> August 5, 2011 **DOCKET** 08-AFC-8 DATE <u>AUG 05 2011</u> RECD. <u>AUG 05 2011</u>

Mr. Aniekan Udobot Hydrogen Energy California One World Trade Center, Suite 1600 Long Beach, CA 90831-1600

# OUTSTANDING INFORMATION NEEDS RELATED TO THE HYDROGEN ENERGY CALIFORNIA PROJECT (08-AFC-8)

#### **BIOLOGICAL RESOURCES - FIGURE 1**

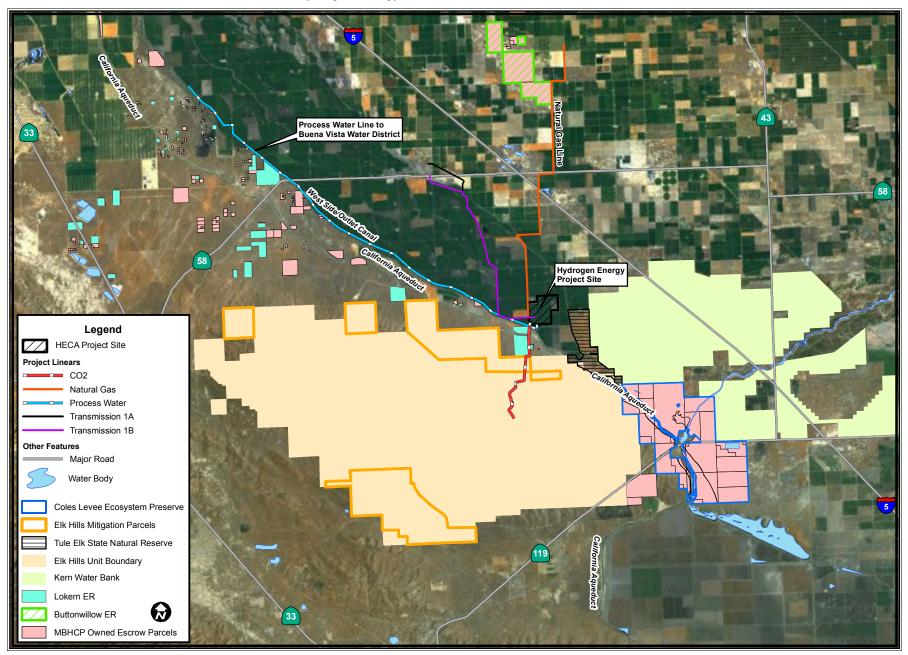
- 9. Revised carbon dioxide pipeline alignment staff requires that the applicant provide an alternative for the carbon dioxide pipeline alignment that would avoid land use conflicts with conservation lands. The current proposal for the carbon dioxide pipeline route would go through lands either under an existing conservation easement or proposed for conservation under the draft Occidental of Elk Hills Habitat Conservation Plan and CDFG is not able to grant a right-of-way permit for a pipeline proposed through conservation lands (Biological Resources Figure 1).

VISUAL RESOURCES - FIGURE 1 Hydrogen Energy California - Project Vicinity and Locations of Key Observation Points

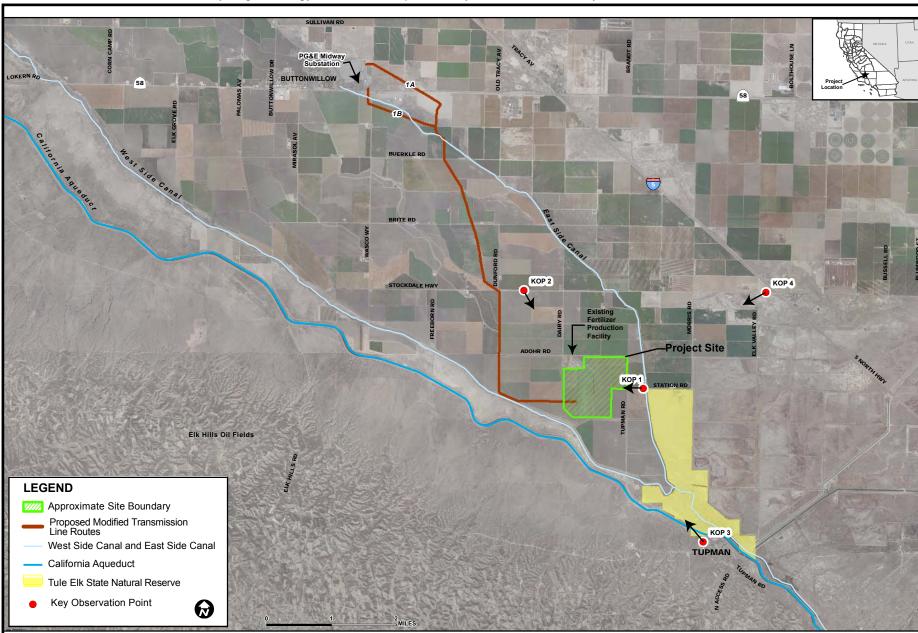
The original May 2009 application for certification included six key observation points (KOPs). Staff determined that four of those six KOPs would be carried forward and included in the visual resources analysis for the Energy Commission's staff assessment. The attached draft figure (**Visual Figure 1**) shows the four KOP locations.

The visual resources analysis for the supplemental filing must re-evaluate the original KOPs in light of the proposed changes to the project. Include a discussion of the suitability of the original KOPs to best represent views of the project site. Suggest new KOPs or modified views (e.g., altered view direction from an original KOP), as necessary, to adequately show the proposed project site and adjacent project facilities that would be visible from the KOPs. Staff requests submittal of any changes to the original KOPs for Staff's review and approval prior to submittal of the supplemental filing.
